Modification of TS-32 to CTS-3

Communications Specialists

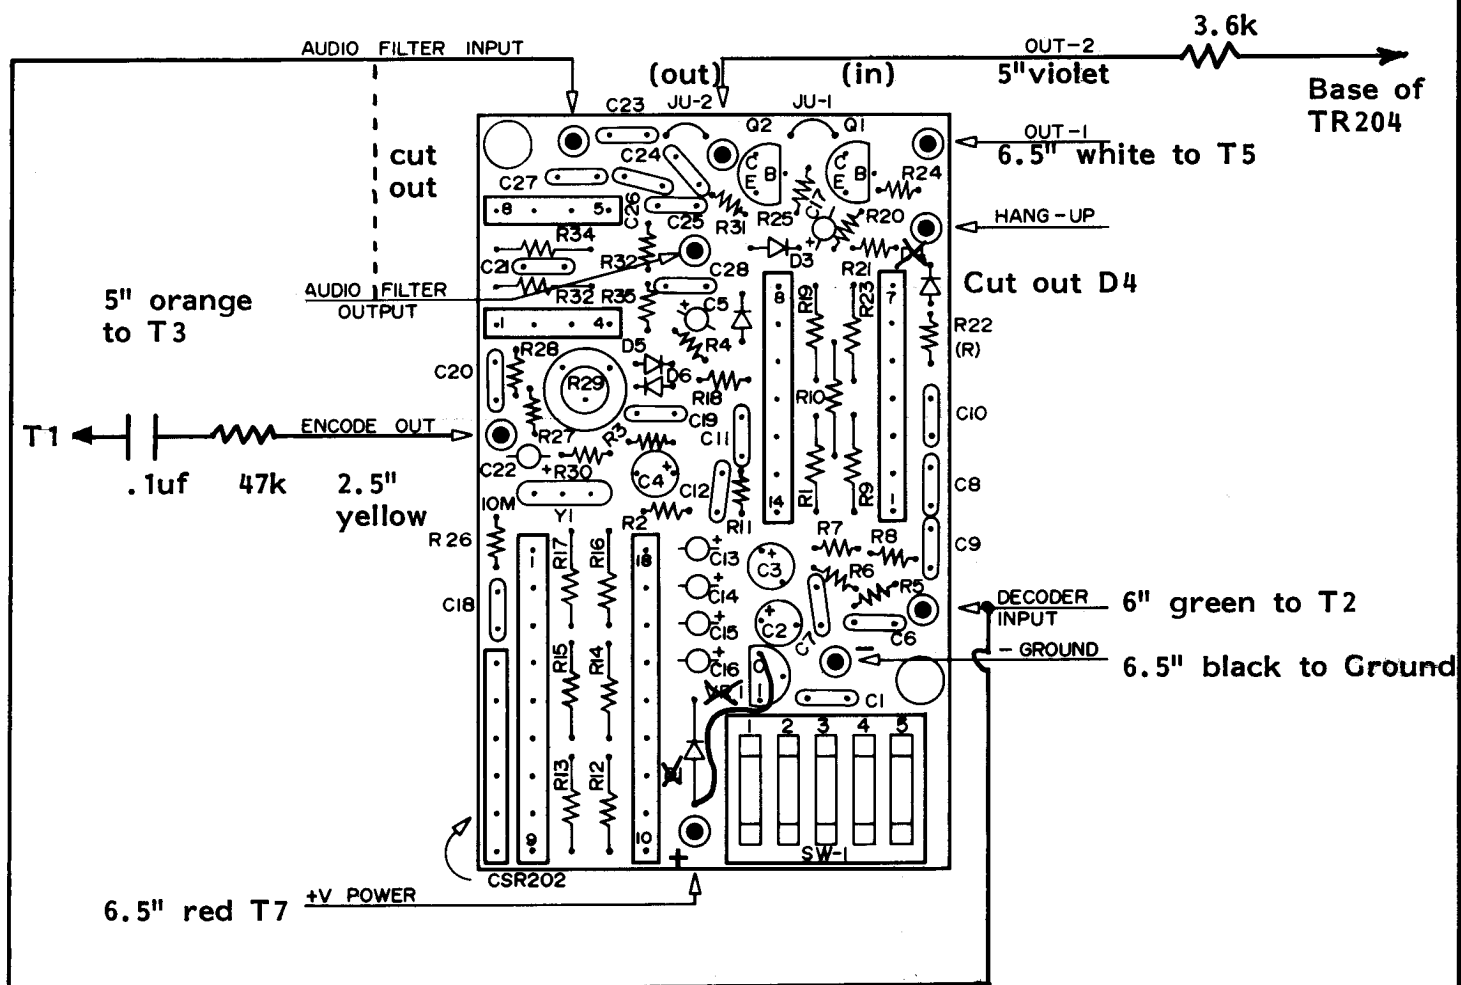
1. Remove D1 and VR1
2. Jumper +V pin to "O" on VR1
3. Bridge R20 with 120k 1/8w on bottom of PCB
4. Cut out D4
5. Cut out JU-2

NOTE: Set tone deviation, then mod.....

1. Remove radio jumper from T2 to T3
2. One side of the tone switch must be grounded (T6)
3. Mount unit with 2 squares of double sided tape

WHEN MOUNTING THE TS-32 WITH A 90 DEGREE ANGLE BRACKET AGAINST THE PCB, BE SURE TO USE THE TWO FIBER SPACERS PROVIDED BETWEEN ANGLE BRACKET AND PCB. IF THIS IS NOT DONE, THE BRACKET WILL SHORT OUT FOILS ON THE PCB
